Addendum 43 – UN Regulation No. 44

Supplement 14 to the 04 series of amendments – Date of entry into force: 29 December 2018

Uniform provisions concerning the approval of restraining devices for child occupants of power-driven vehicles ("Child Restraint Systems")

Figures for the explanation of the measurement procedure

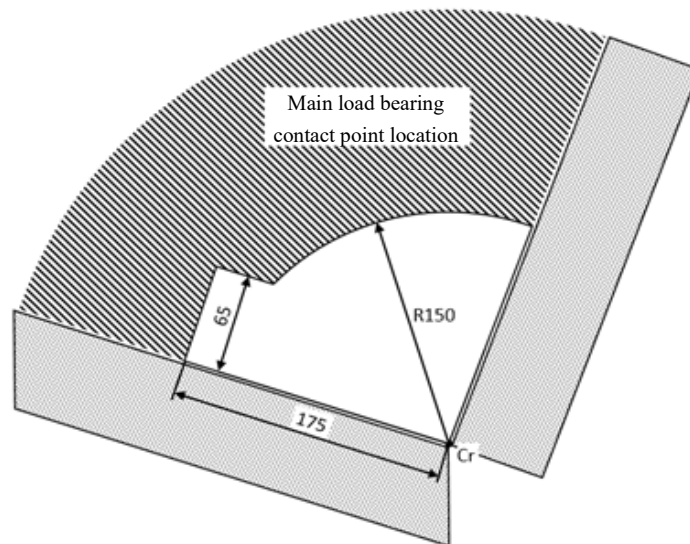
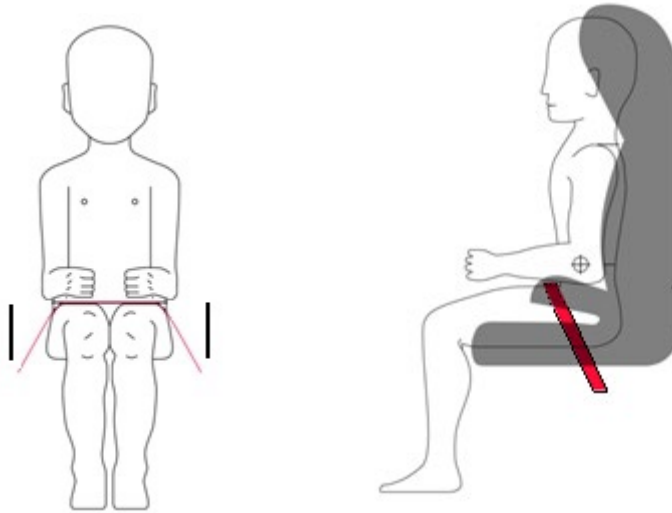
Paragraph 6.1.8., amend to read:

"6.1.8. Integral child restraint systems of the "universal" category, except ISOFIX universal child restraint systems, shall have a main load-bearing contact point, between the child restraint and the webbing of the adult safety-belt. This point shall not be less than a radius of 150mm from the Cr axis when measured with the child restraint as indicated in figures below, on the dynamic test bench installed in accordance with Annex 21 to this Regulation without a dummy.

Non-integral child restraint systems of the "universal" category, shall have a main load-bearing contact point, between the child restraint and the webbing of the adult safety-belt. This point shall not be less than 65 mm vertically above the test bench cushion and not be less than a radius of 150mm from the Cr axis when measured with the child restraint as indicated in figures below, on the dynamic test bench installed in accordance with Annex 21 to this Regulation without a dummy.

The check shall be done at both sides of the CRS and along a longitudinal plane parallel to the median plane of the CRS.

Figures of Strapped child

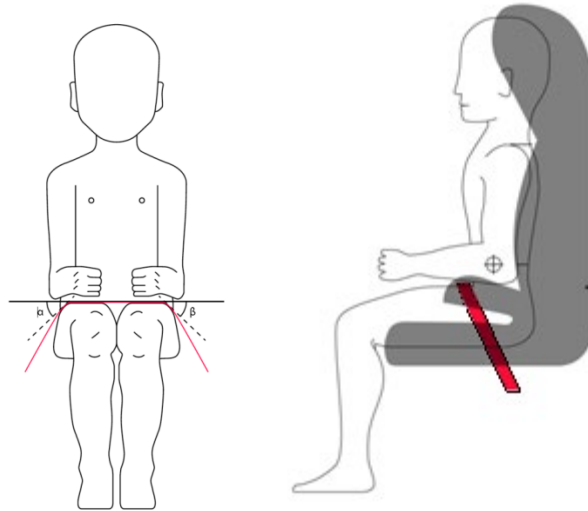
Paragraph 6.2.2., amend to read:

"6.2.2. All restraint devices utilizing a "lap strap" shall positively guide the "lap strap" equilateral on both sides to ensure that the load transmitted by the "lap strap" are transmitted through the pelvis. The assembly shall not subject weak parts of the child's body (abdomen, crotch, etc.) to excessive stresses. "

In the case of booster cushions and booster seats, the lap portion of the adult seat belt shall be positively guided equilateral on both sides to ensure that the loads are transmitted by the adult lap belt are transmitted through the pelvis. The positive guidance of loads over the pelvis shall be realised from the moment that the child is installed; the lap belt shall pass over the top of the thigh, just touching the fold with the pelvis. The angles α and β between the tangent line in which the belt touches the thighs and the horizontal shall be greater than 10° ."

"Figure 7

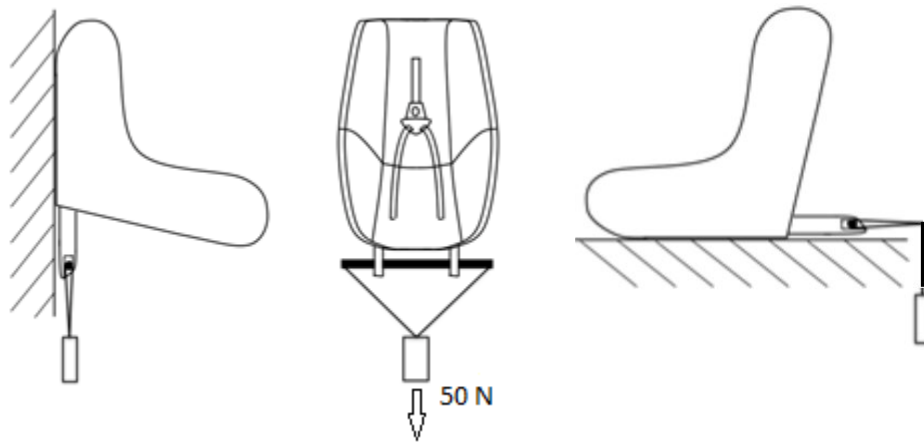
Paragraph 8.2.9., amend to read:

"8.2.9. The complete seat, or the component fitted with ISOFIX attachments (e.g. ISOFIX base) if it has a release button, is attached rigidly to a test rig in such a way that ISOFIX connectors are aligned as shown in Figure 7. A 6 mm diameter bar, 350 mm long, shall be attached to the ISOFIX connectors. A force of 50 ± 1 N shall be applied to the extremities of the bar."

Figure 7, amend to read:
